Sundry Notices and Reports on Wells

9. Redfern #5E
API Well No.

30-045-24403

PLUG AND ABANDONMENT PROCEDURE

Proposed P&A

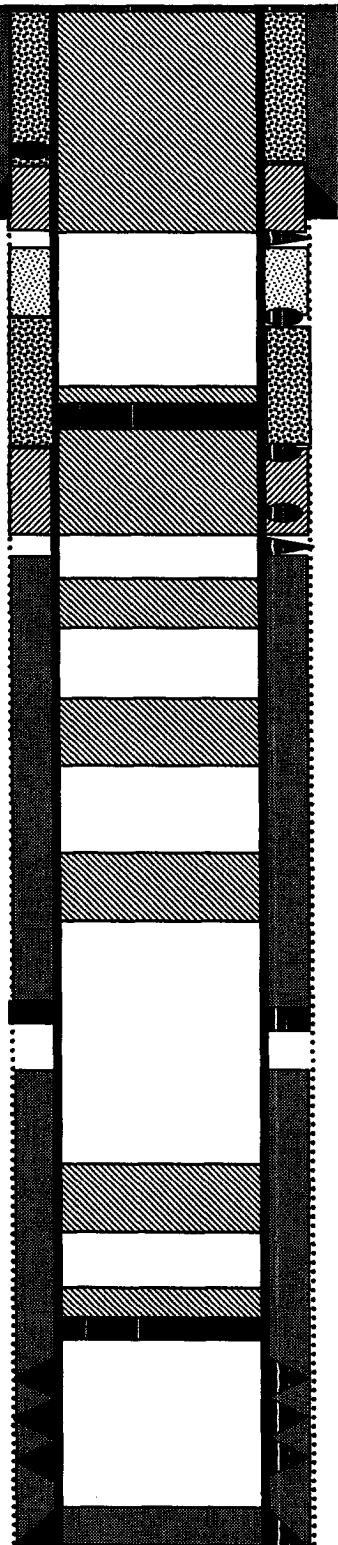
Verbal approval was given by the BLM (Steve Mason) and OCD (Steve Hayden) to proceed with the P&A. The change given by the BLM was to set the Fruitland plug from 1285' - 1185'; and the Kirtland plug from 596' - surface.

6. **Plug #6 (Fruitland top, ^{1285'}1313' – ^{1185'}1213')**: Perforate 3 squeeze holes at ^{1285'}1313'. TIH with open ended tubing and spot 35 sxs from 1320' to 1100'. PUH to 1120' and reverse circulate clean. TOH with tubing. TIH and set 4.5" cement retainer at 1100'. Mix cement to fill the tubing and then sting into the CR. Pressure up to 2000# and attempt to squeeze 35 sxs outside the 4.5" casing into perforation at 1313' and existing squeeze holes at 1272' and 1250'. Sting out of retainer and spot 11 sxs cement above CR. TOH with tubing.

7. **Plug #7 (8.625" Casing shoe, Kirtland, Ojo Alamo and surface, ^{596'}560' – 0')**: Perforate 3 squeeze holes at ^{596'}560'. TIH with tubing. Mix 45 sxs Type III cement to fill casing from 610' to surface. TOH and LD tubing. Mix additional cement to squeeze cement outside the 4.5" casing up to 1500#. Shut in well and WOC.
